SAND CREEK RESTORATION

PUBLIC IMPROVEMENT CONSTRUCTION PLANS

EPC STORMWATER REVIEW COMMENTS ARE SHOWN IN ORANGE BOXES WITH BLACK TEXT

PCD-ENGINEERING REVIEW COMMENTS IN BLUE BOXES WITH BLUE TEXT

POND W-3 PLAN
SCALE: 1"=100'

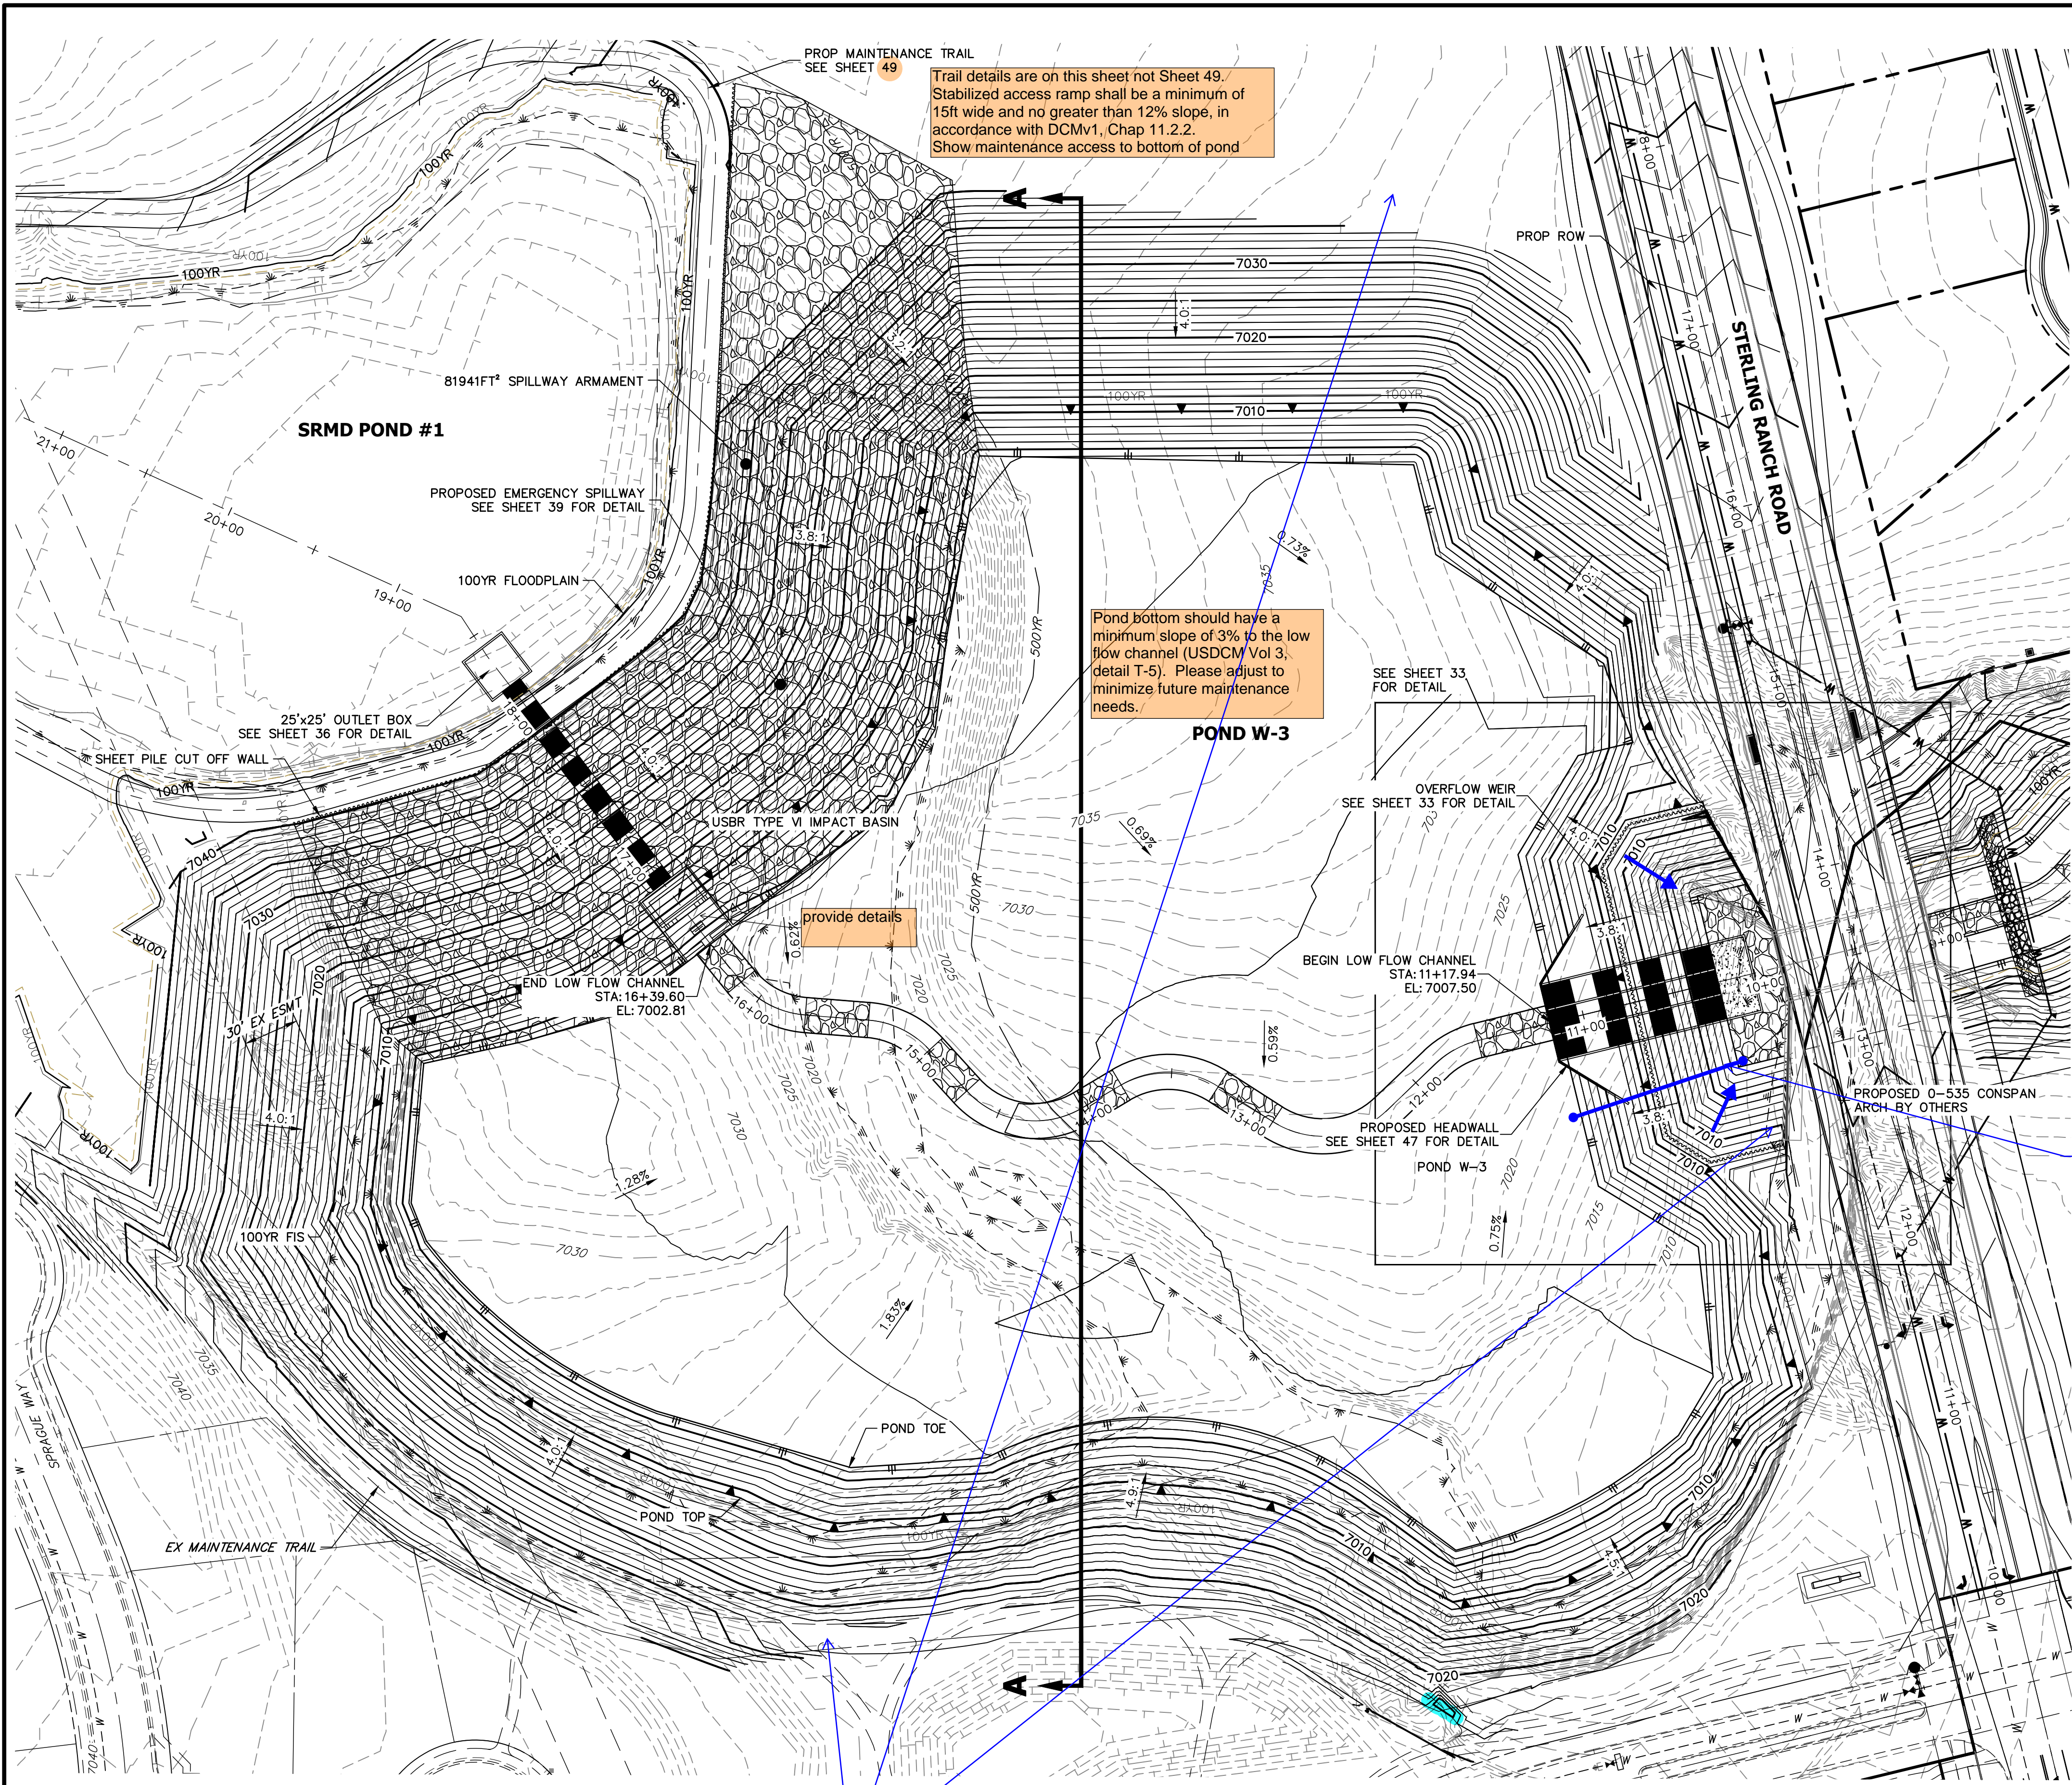
Provide cross-section

GRouted STEPPED BOULDER DROP #1 DETAIL
PLAN VIEW
SCALE: 1"=20"

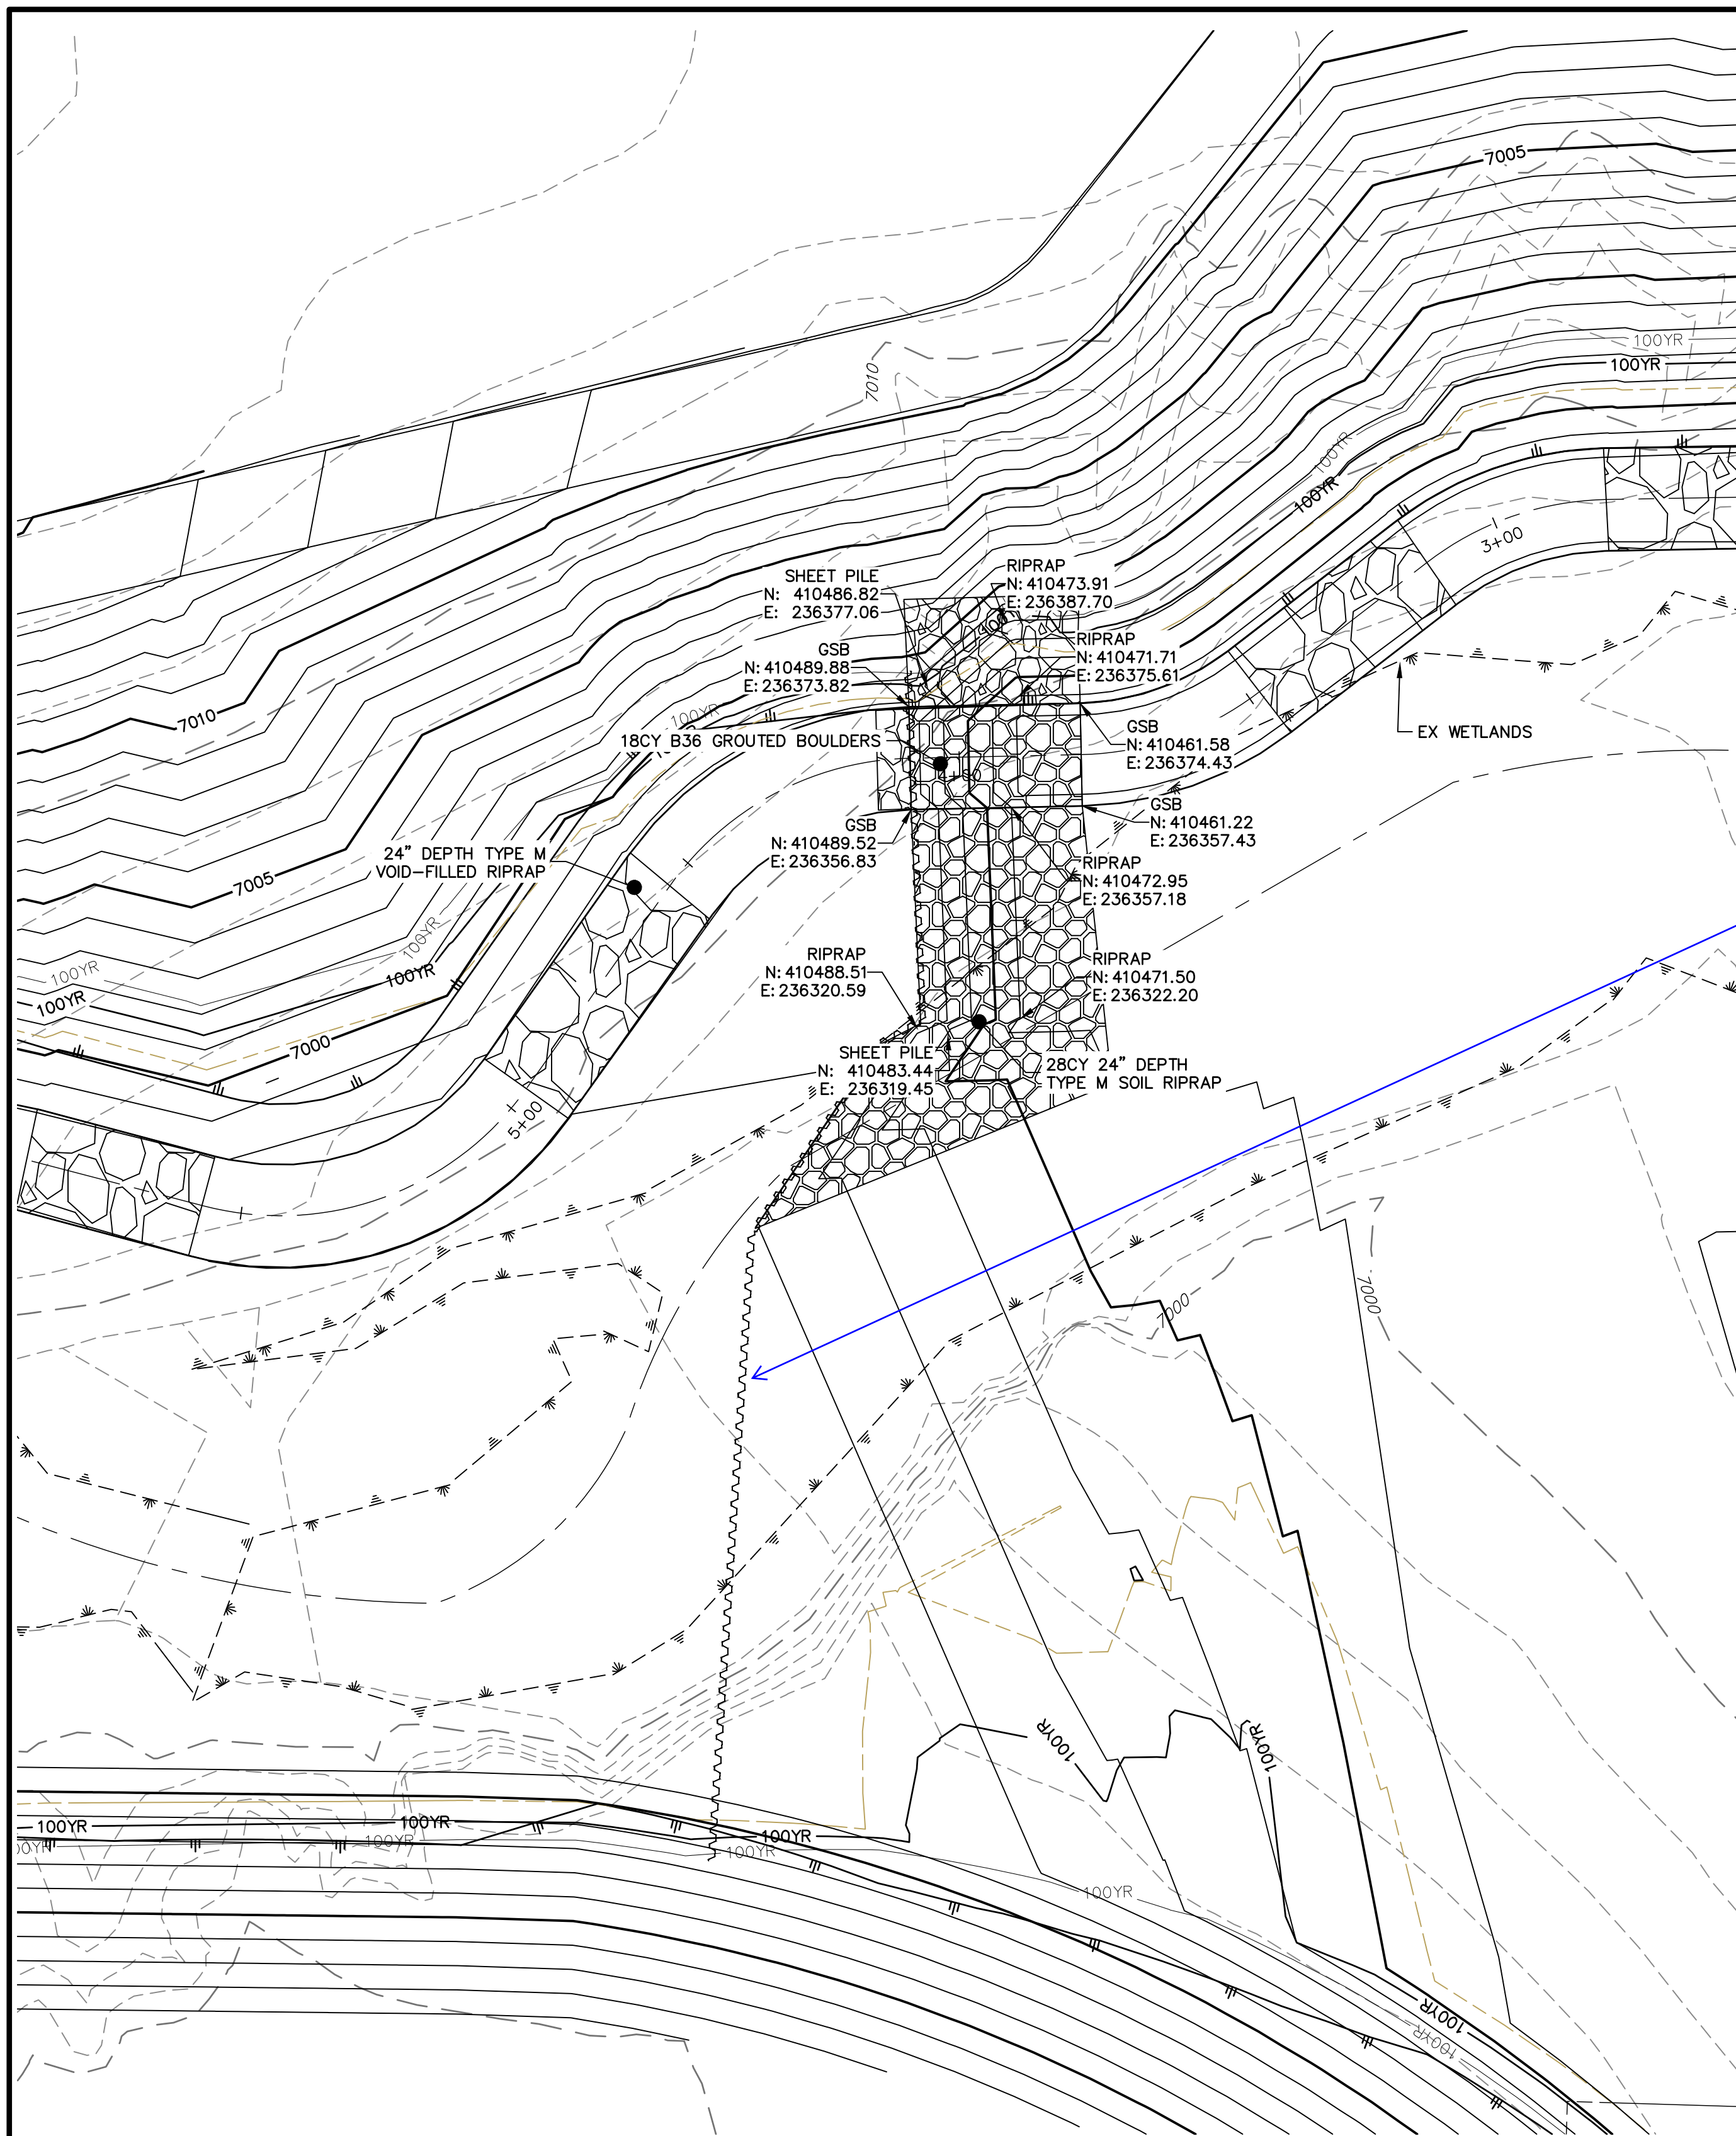
Provide profile of the sheet pile structure

GSB PROFILE 2
STA 7+00.00 TO 10+00.00

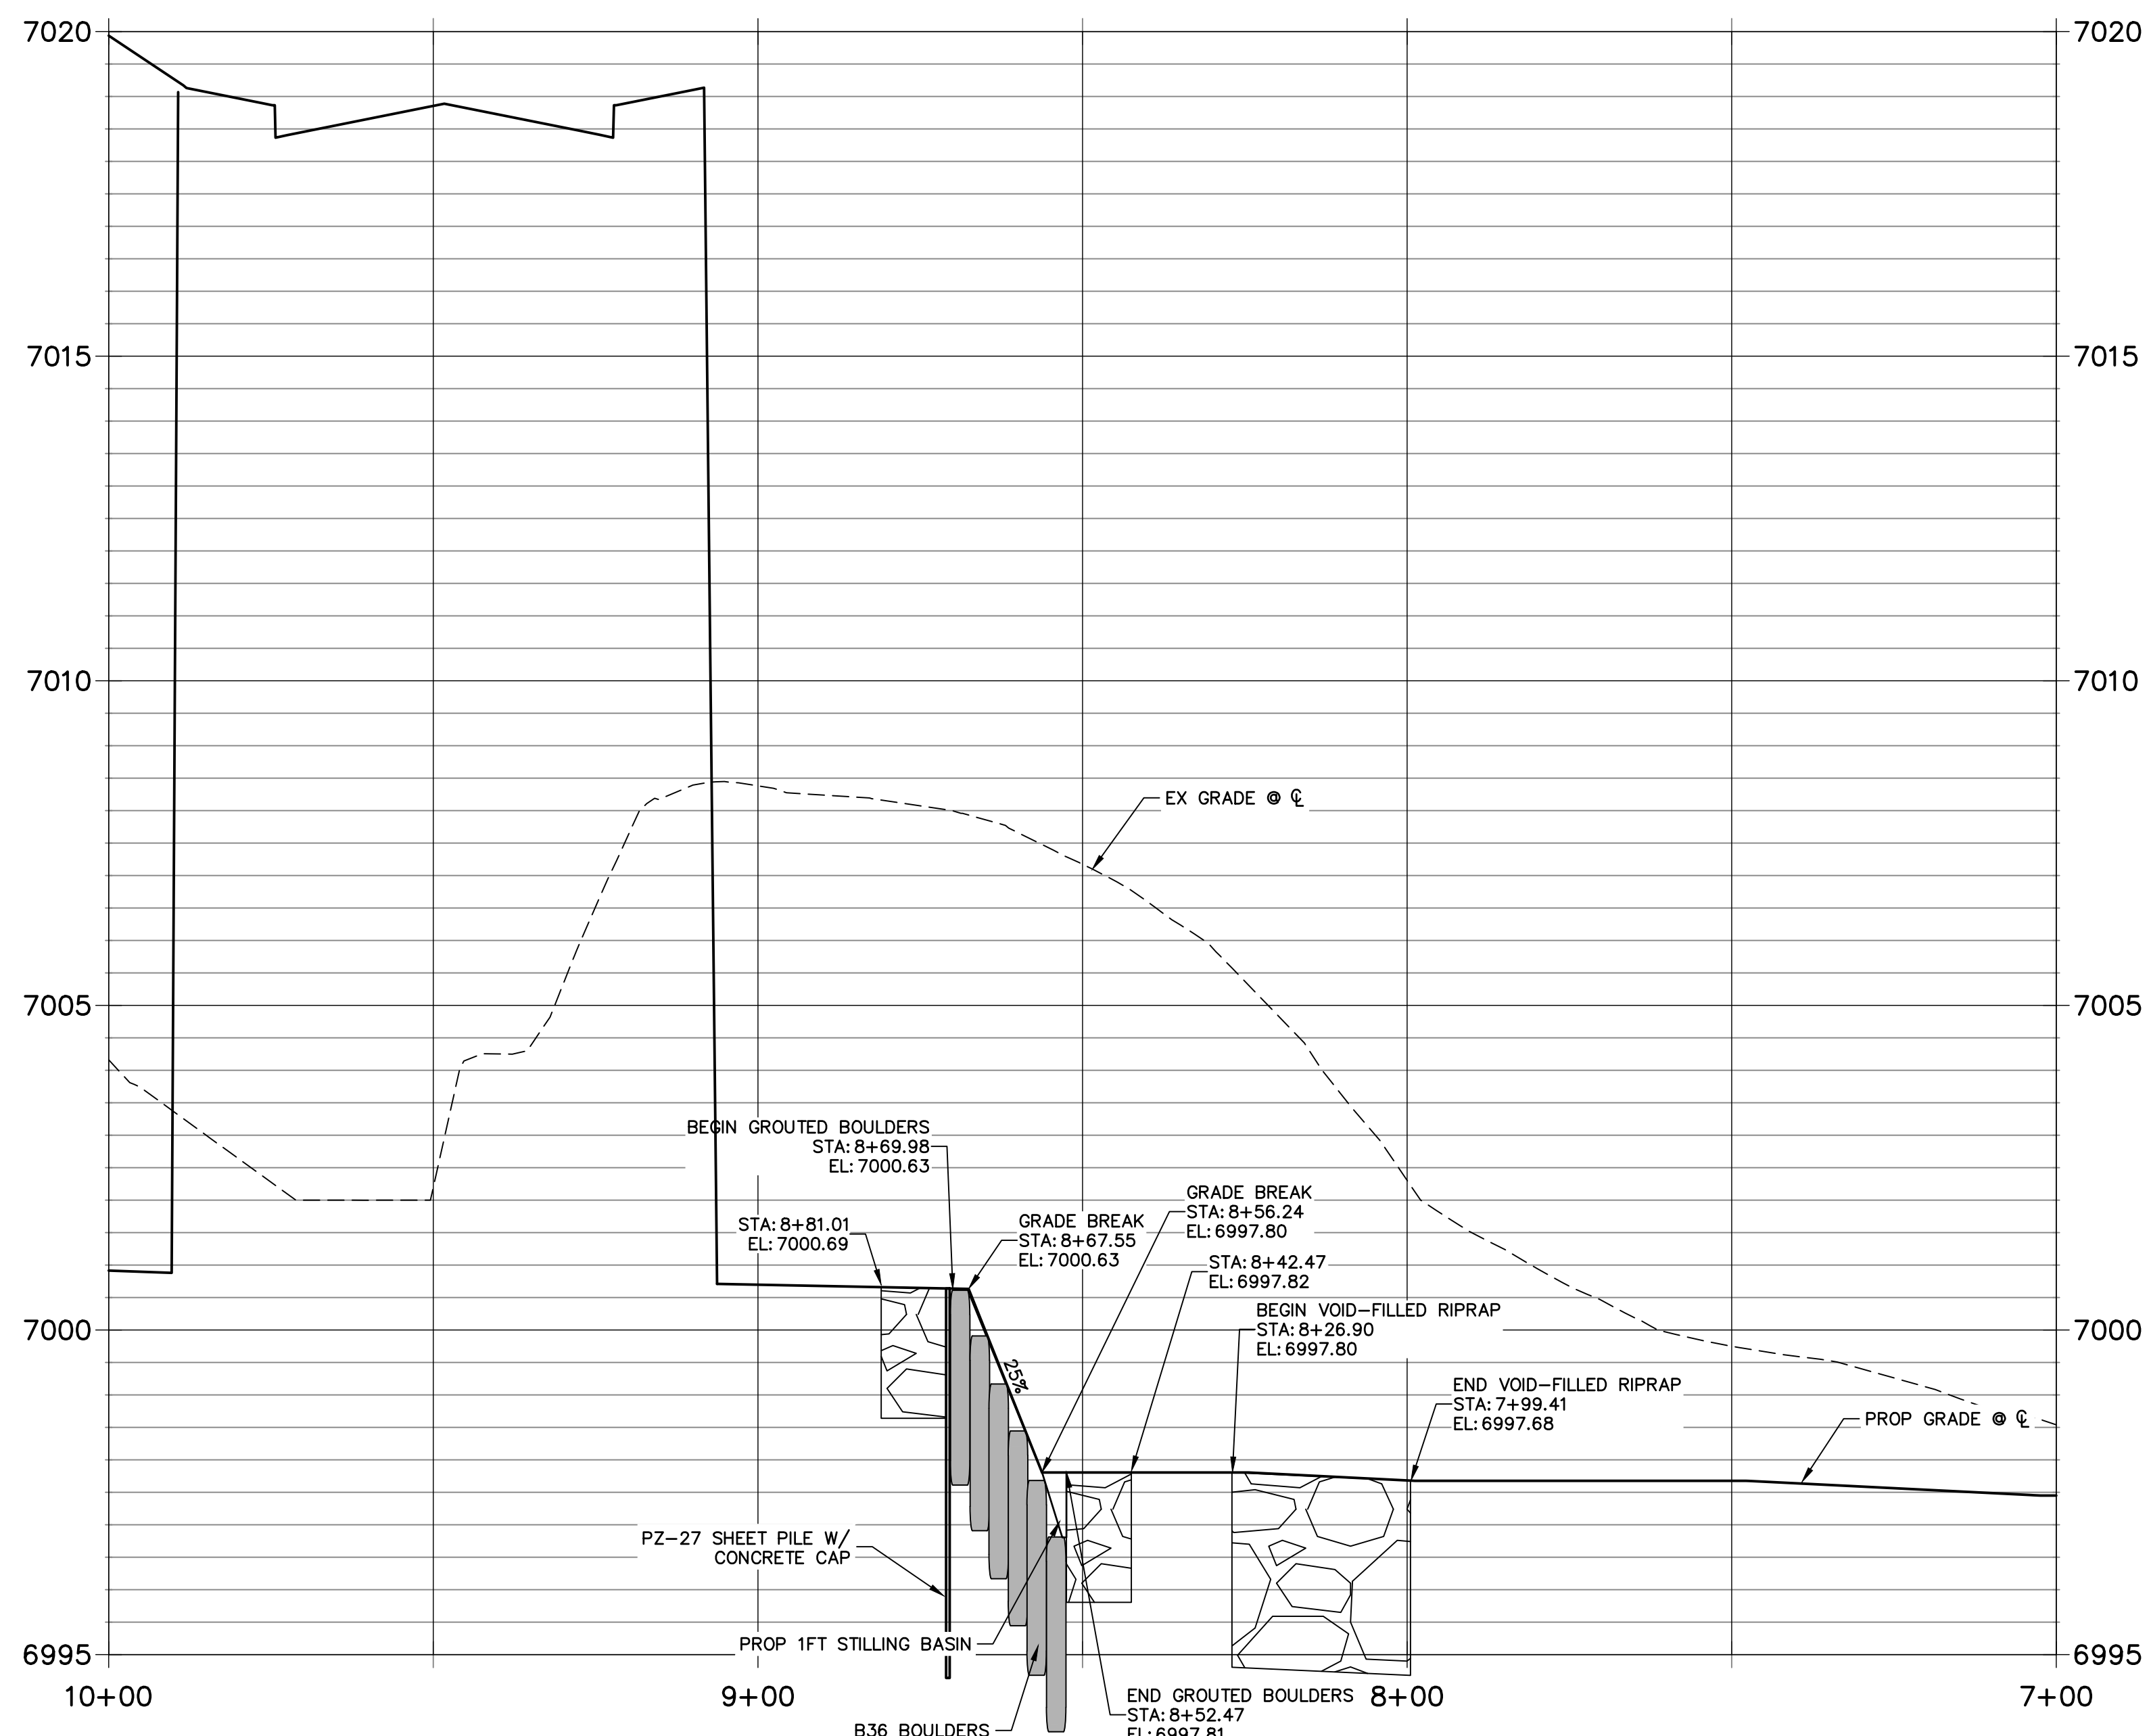
Show maintenance access
